SEARS - AURORA MALL
14200 EAST ALAMEDA AVENUE, AURORA, COLORADO

ADMINISTRATIVE AMENDMENT

AURORA MALL EXPANSION LRDP

SITE PLAN AMENDMENT

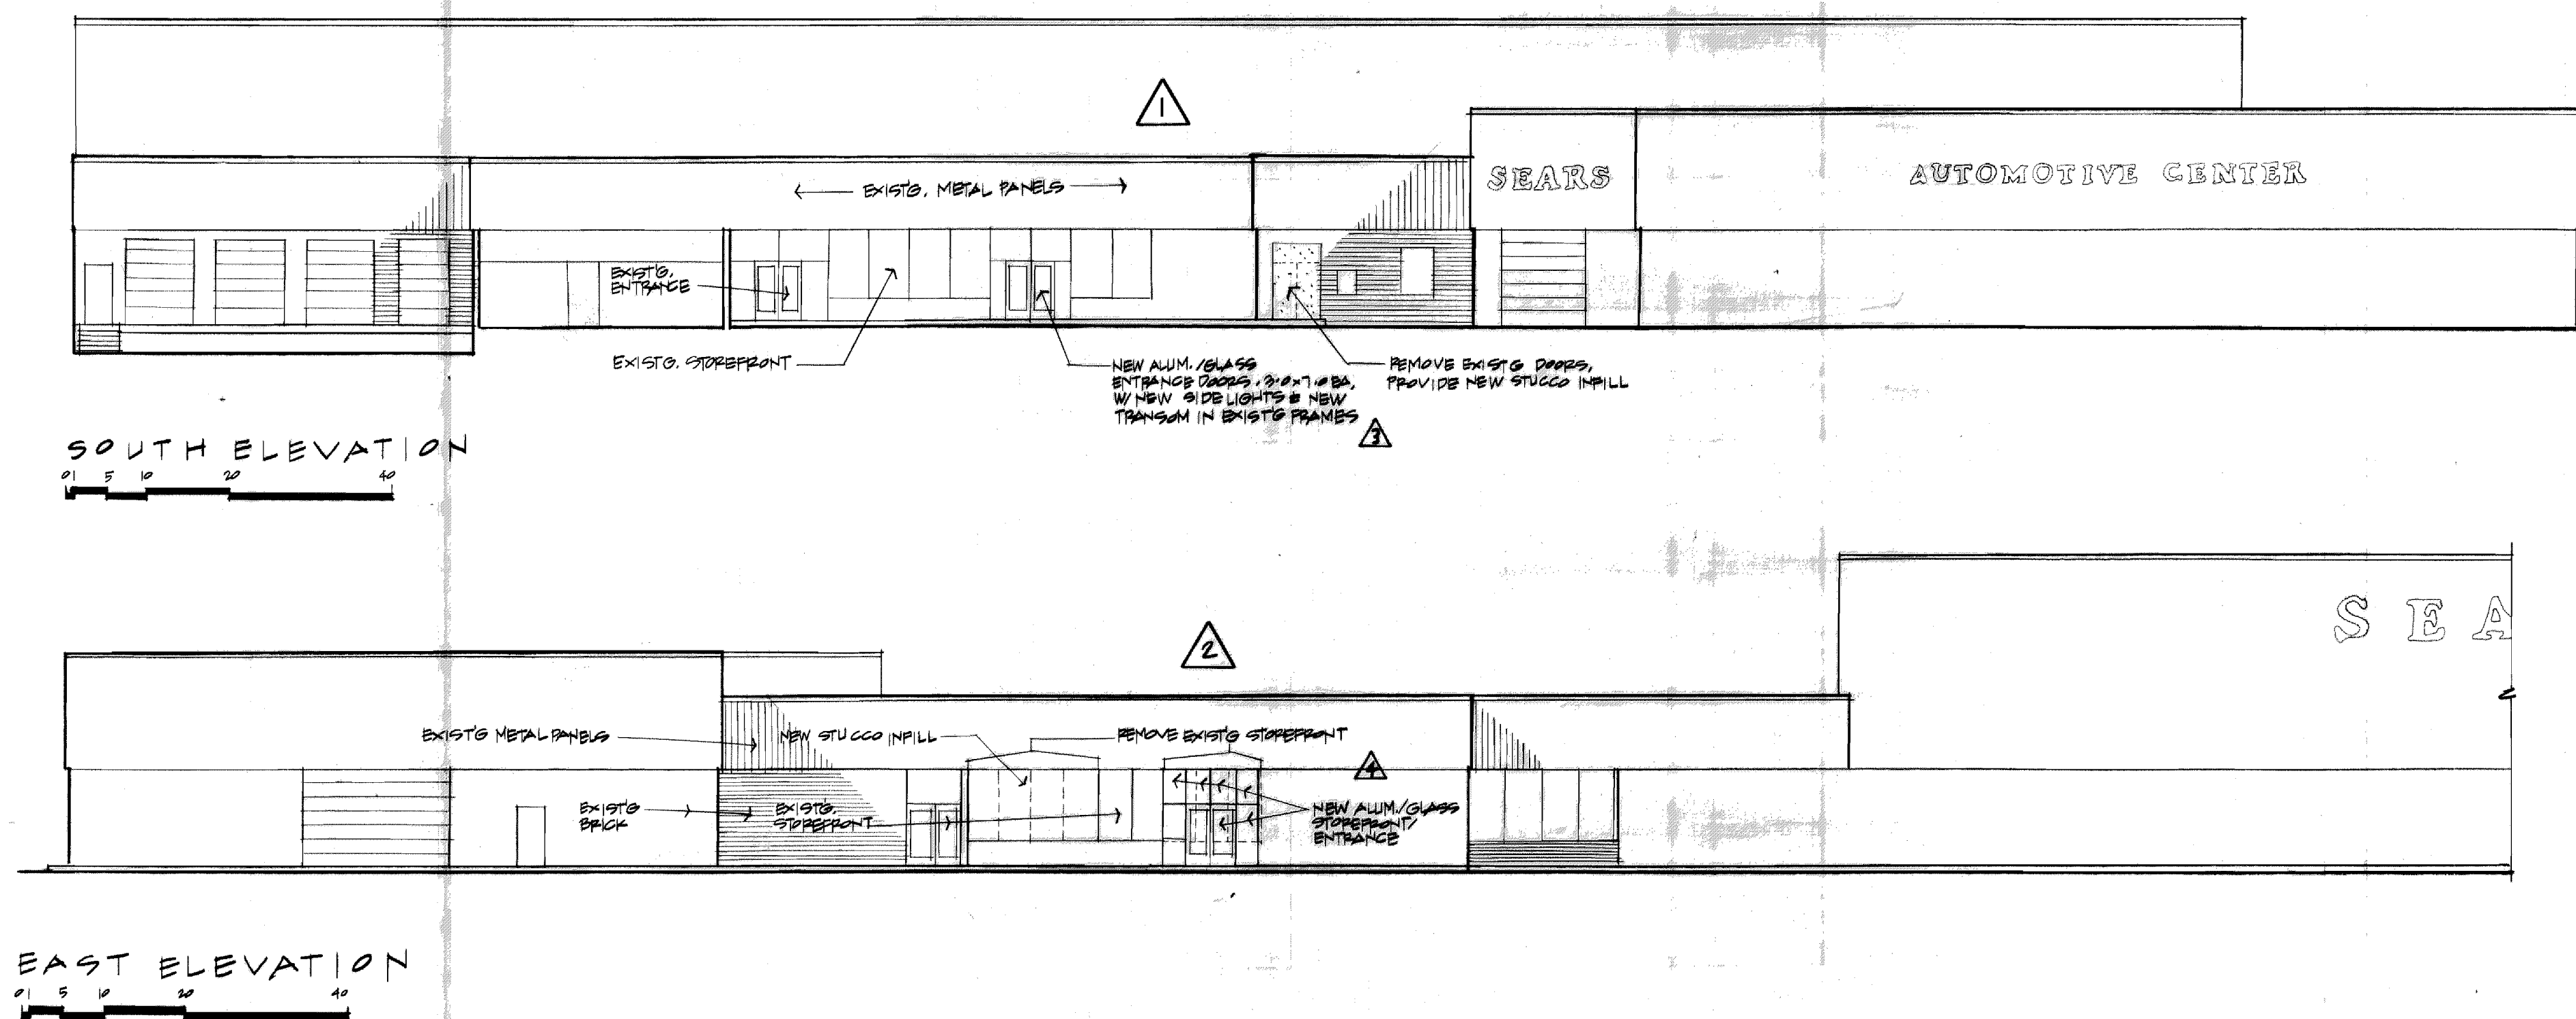
- ① CHANGE TO EXTERIOR ENTRANCES AT SOUTH ELEVATION - (ADDITION OF ONE NEW ENTRANCE, CLOSURE OF ONE EXISTO. ENTRANCE)
- ② CHANGE TO EXTERIOR ENTRANCES & STOREFRONT AT EAST ELEVATION - (ADDITION OF ONE NEW ENTRANCE)

SITE PLAN

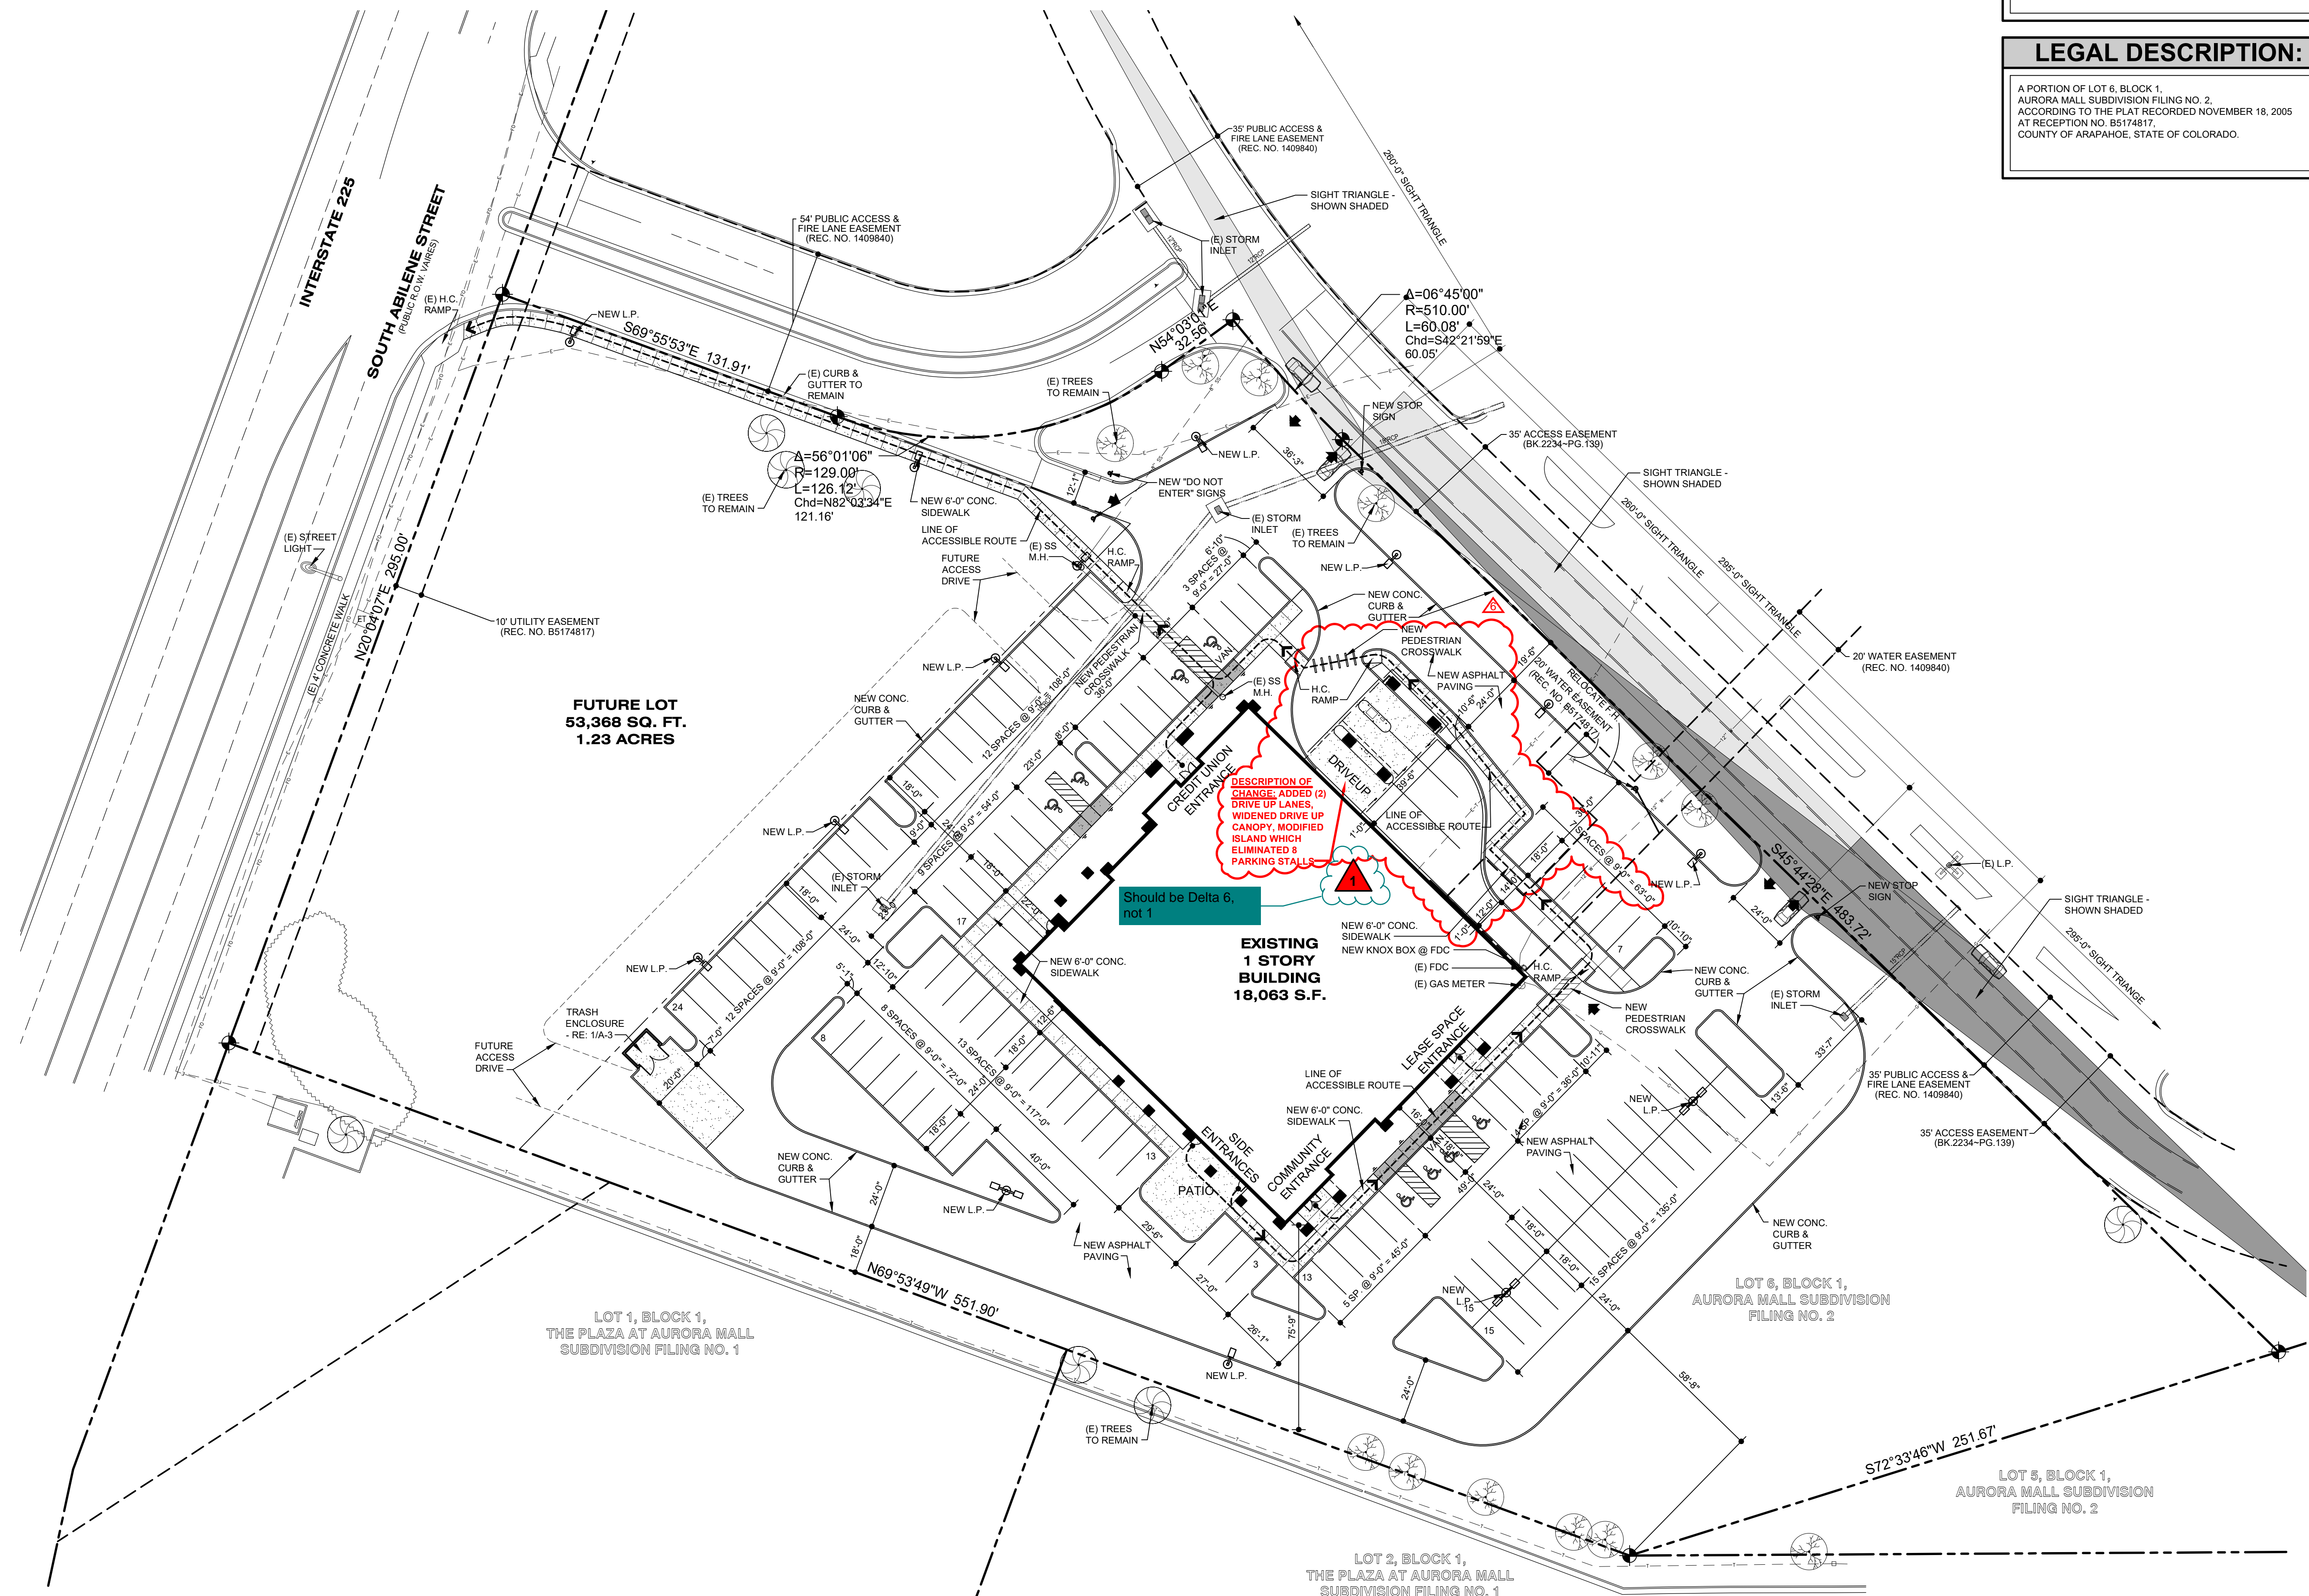
04.16.2024 MA-1995-6028-22 - ADDITION OF TWO DRIVE UP LANES AND EXTENSION OF DRIVE UP CANOPY
